**Re: GE-Pittsfield/Housatonic River Site  
East Street Area 1-North (GEC430)  
Addendum to Pre-Design Investigation Work Plan**

This letter serves as the Addendum to the PDI Work Plan and addresses each of the comments contained in EPA's conditional approval letter. In addition, this Addendum includes updated versions of Tables 3 and 4 and all figures from the PDI Work Plan, which have been revised based on EPA comments.

FIGURE  
**1**

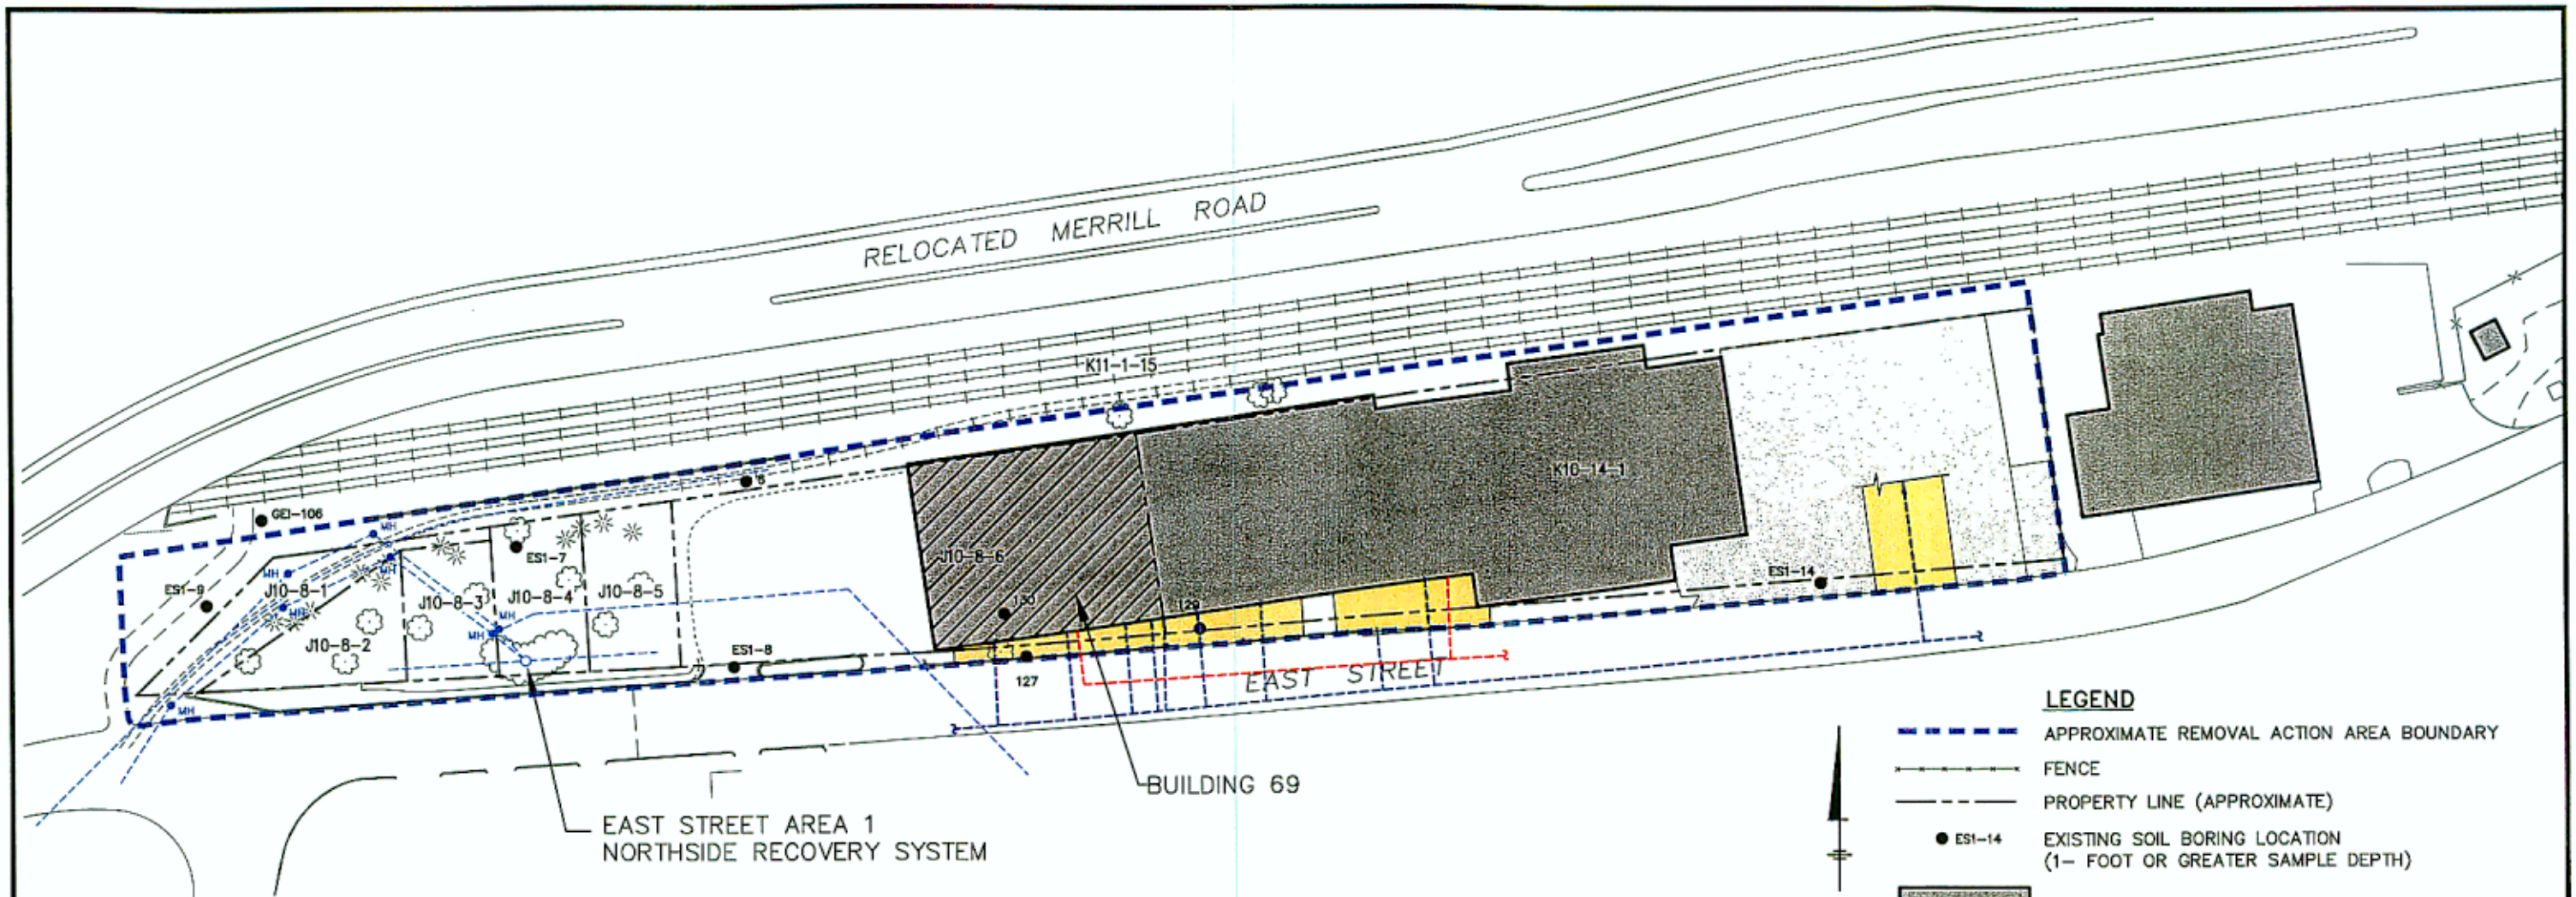
1. GE has revised Figures 1 through 6 to reflect the agreed-upon location of the northern extent of the East Street Area 1-North Removal Action Area (RAA). As required in Condition No. 1 of EPA's conditional approval letter, and as shown on Figure 3, GE proposes to collect additional soil samples along the northern portion of the RAA, at locations generally corresponding to pre-design grid nodes RAA6-B7, RAA6-A11, and RAA6-C2. These proposed sampling locations have been modified from their grid nodes to take into account the existing building, the RAA boundary, and property ownership, respectively. The PDI Work Plan tables and figures have been updated to reflect these additional samples.

**EXISTING SAMPLING LOCATIONS**

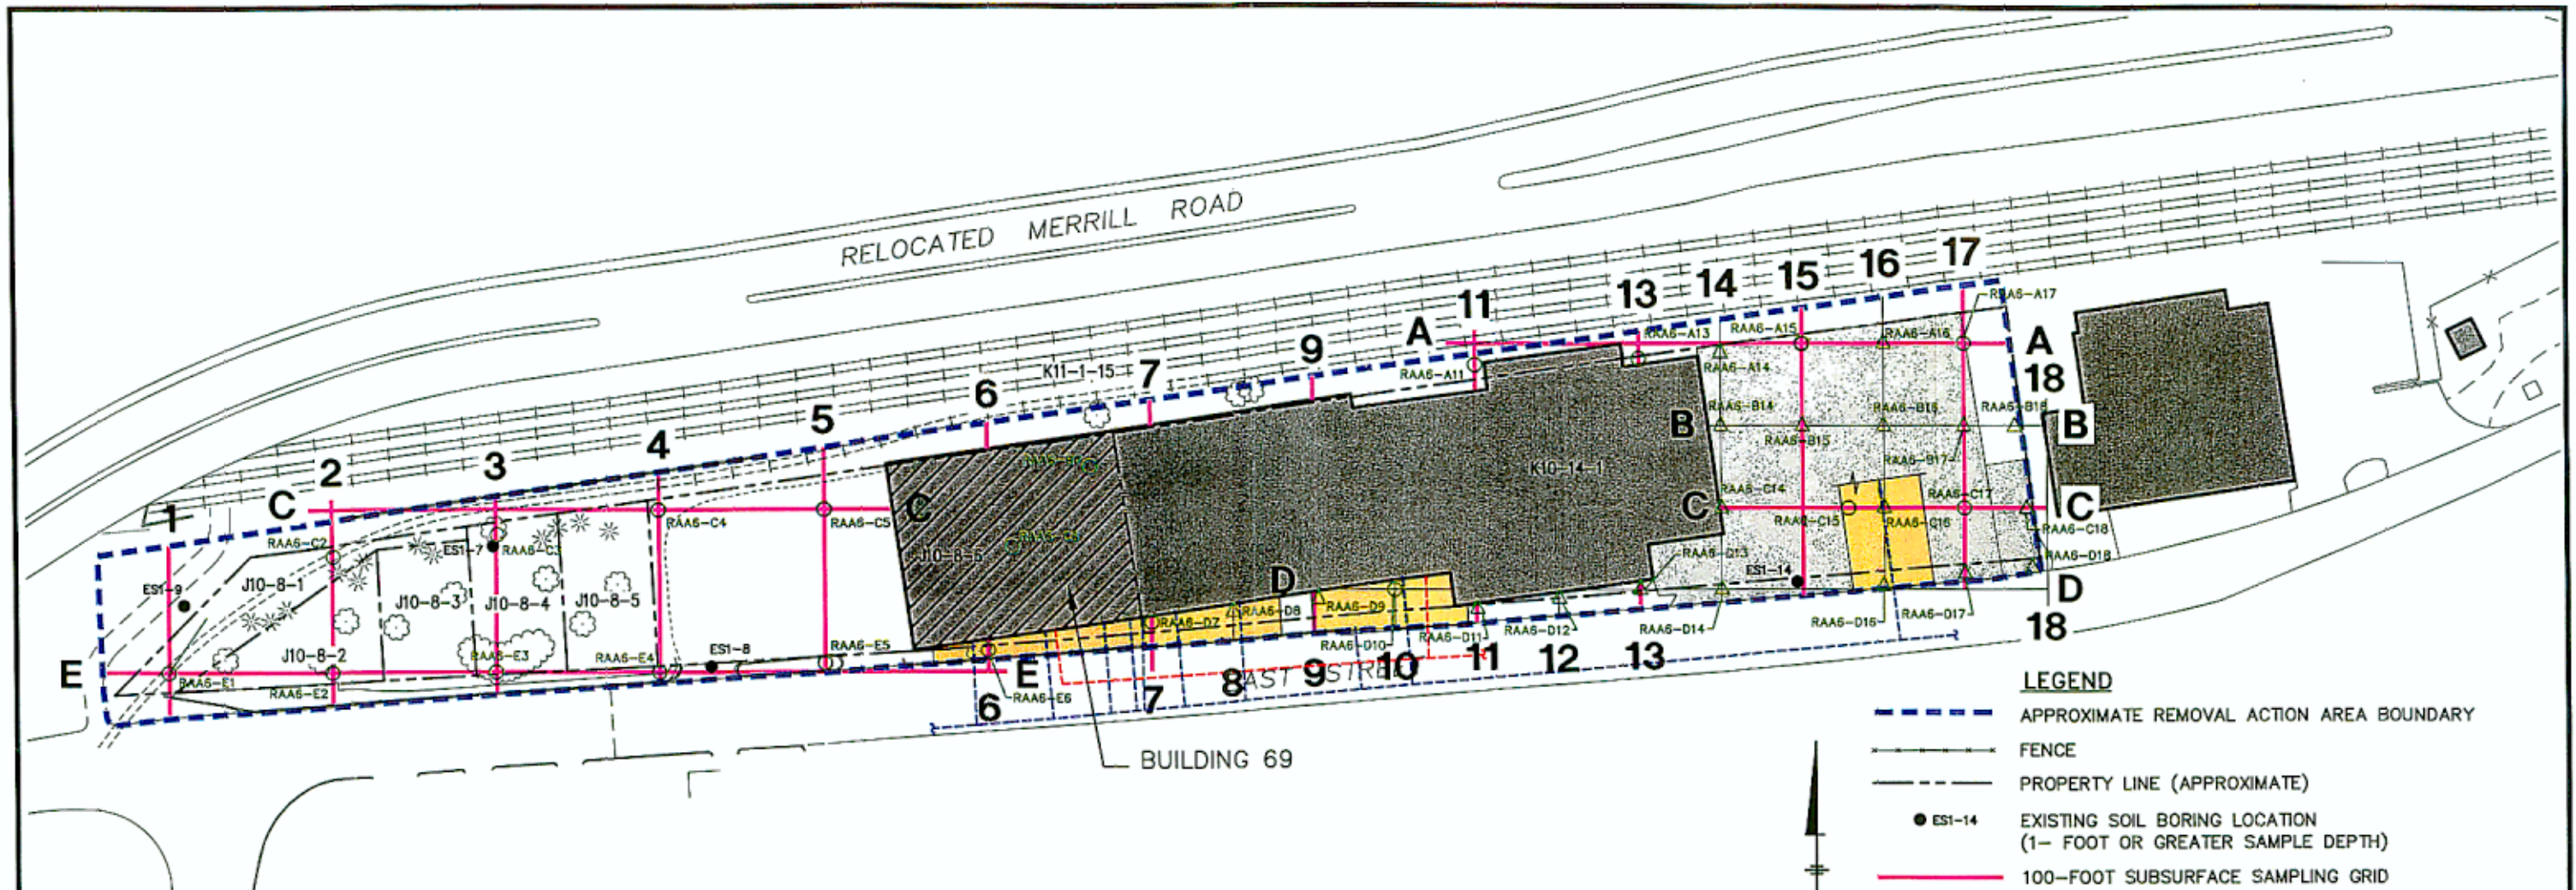
- Parcel J10-8-1 is currently owned by GE. GE has no information regarding the past ownership or uses of this parcel. Currently, this vacant parcel contains various subsurface piping associated with the East Street Area 1 Northside Oil Recovery System (Figure 2), discussed below.

7. Consistent with Comment No. 7 of EPA's conditional approval letter, GE has modified the shading pattern on Figures 2 through 6 to better differentiate between paved and unpaved areas.

FIGURE  
**3**

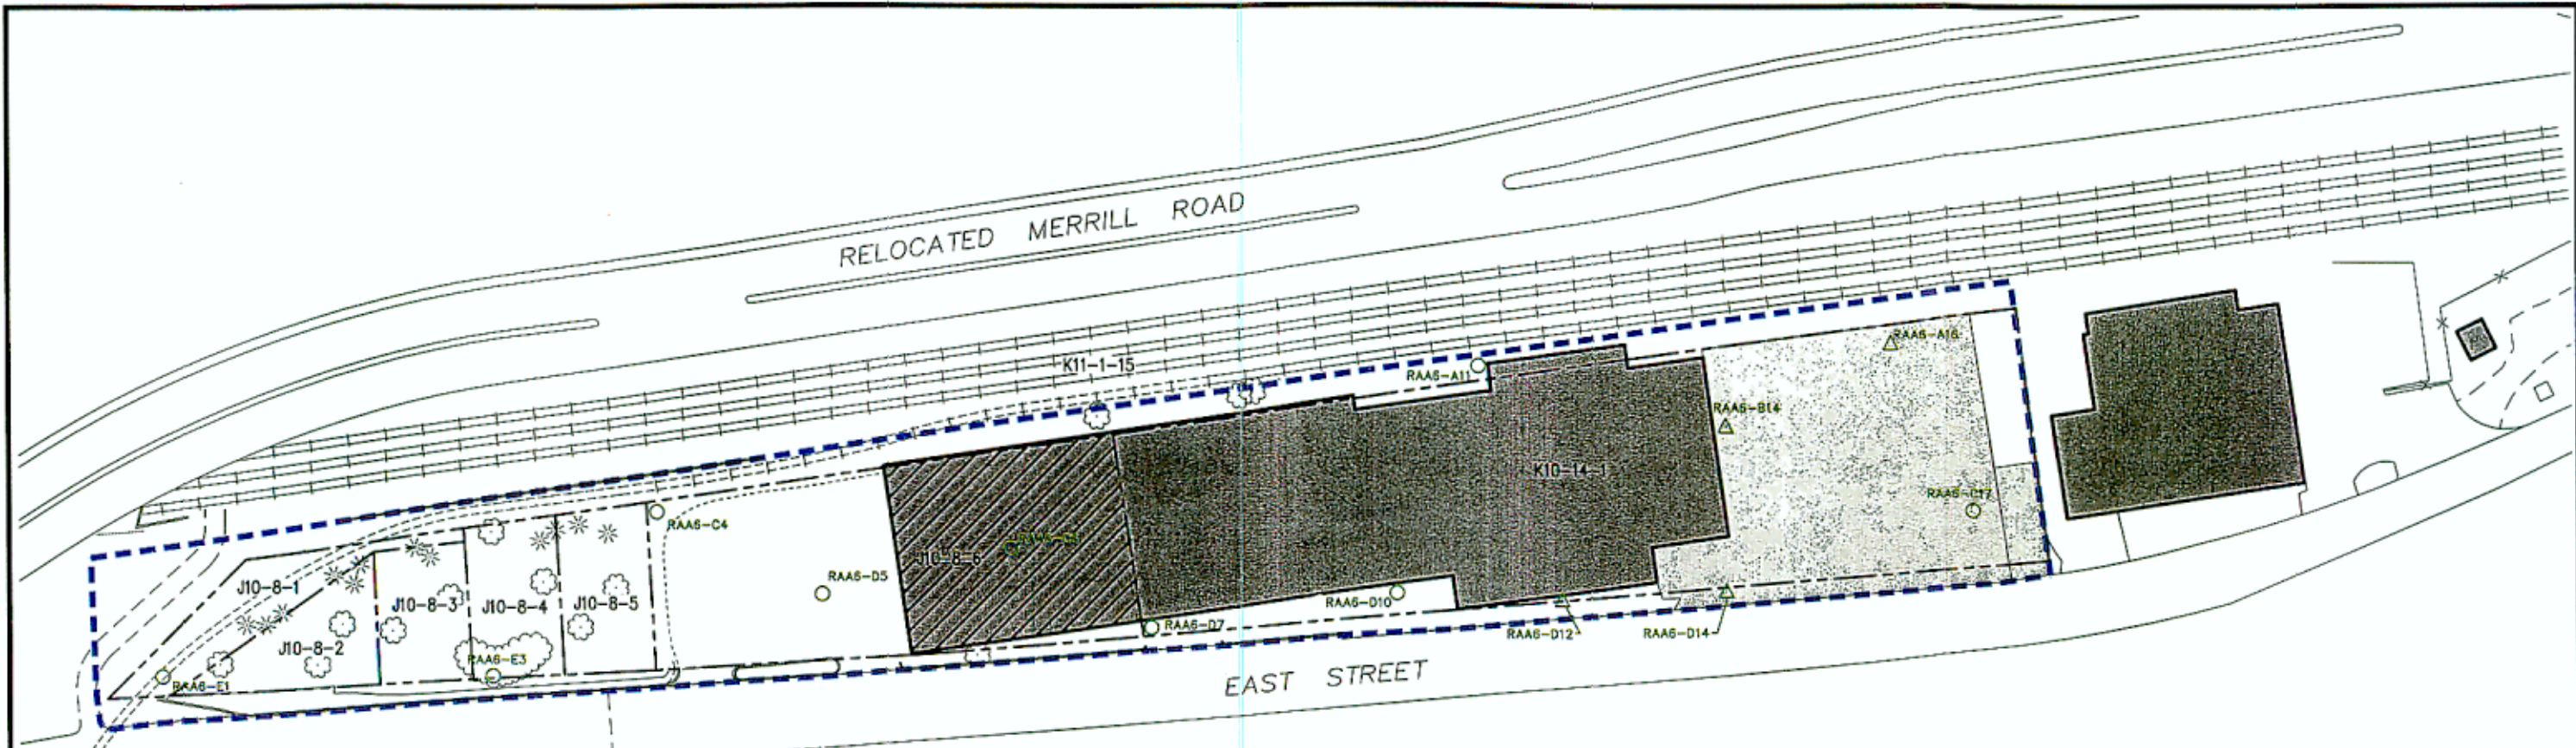
3. As required by Condition No. 3 of EPA's conditional approval letter, GE has adjusted the locations of proposed pre-design samples RAA6-E1, RAA6-E2, RAA6-E3, RAA6-E4, RAA6-E5, and RAA6-C4 to fall on or extremely close to their specific grid nodes. (Previously, these samples had been proposed at locations slightly offset from the actual grid nodes.) In addition, pre-design soil sample RAA6-C3 has been offset from its specific grid node to a location on GE-owned property. Figures 3 through 6 have been revised to reflect the adjusted sample locations.

4. EPA's Condition No. 4 required a modification of the pre-design sampling scope with respect to subsurface utilities. Specifically, grid location RAA6-D10 has been changed from a surface soil sample location to a soil boring location and grid location RAA6-D9 has been changed from a soil boring location to a surface soil sample location. Figures 3 through 6 and Tables 3 and 4 have been revised to reflect this change.

GENERAL ELECTRIC COMPANY  
PITTSFIELD, MASSACHUSETTS  
PRE-DESIGN INVESTIGATION WORK PLAN  
FOR EAST STREET AREA 1 - NORTH  
**PROPOSED APPENDIX IX+3  
SAMPLING LOCATIONS  
(0- TO 1-FOOT DEPTH INTERVAL)**

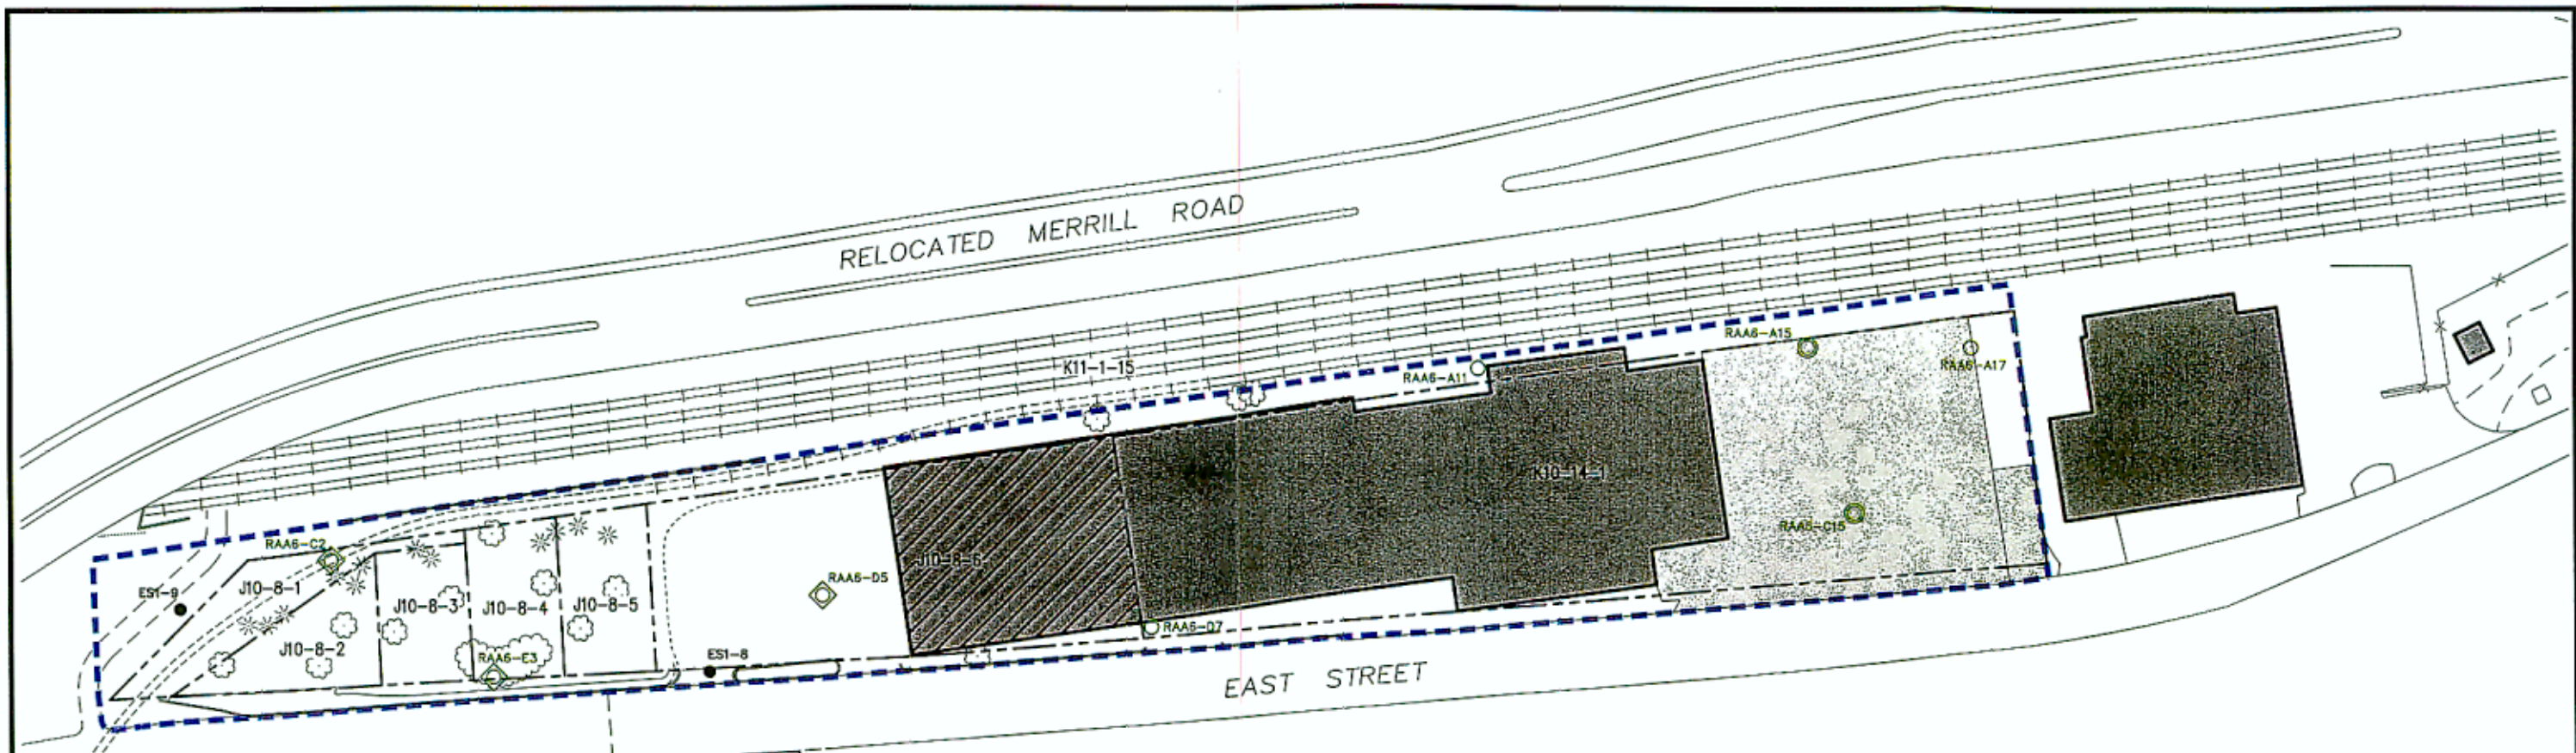
5. Figures 4 through 6 and Table 4 has been revised to reflect modifications to the proposed Appendix IX+3 sampling, as required by Condition No. 5 of EPA's conditional approval letter. A summary of the changed Appendix IX+3 sample locations follows:

0- to 1-foot interval:

- RAA6-B17 was moved to RAA6-A16;
- RAA6-C5 was moved to RAA6-D5;
- RAA6-E5 was eliminated; and
- RAA6-A11 was added.

FIGURE  
**5**

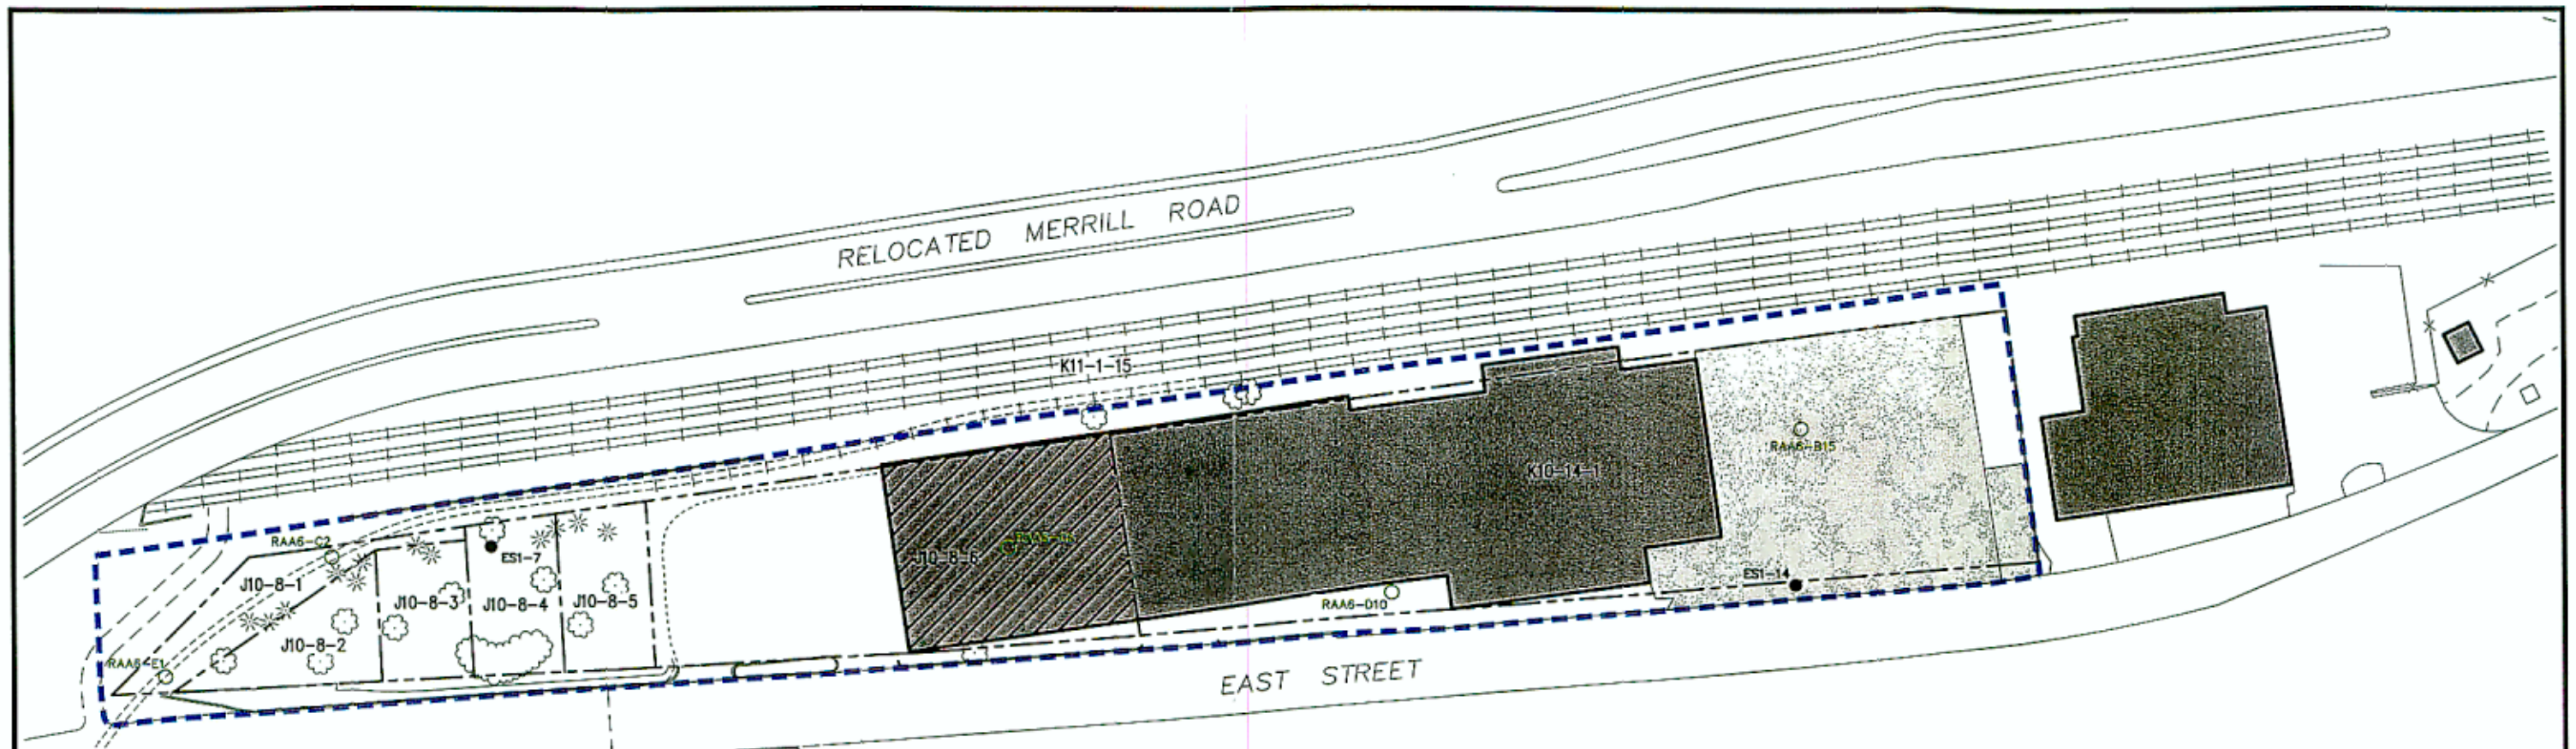
1- to 6-foot interval:

- RAA6-C17 (3- to 6-foot depth sample) was moved to RAA6-C15;
- RAA6-A11 (1- to 3-foot depth sample) was added;
- RAA6-C2 (1- to 6-foot depth sample) was added; and
- RAA6-D5 (1- to 6-foot depth sample) was added.
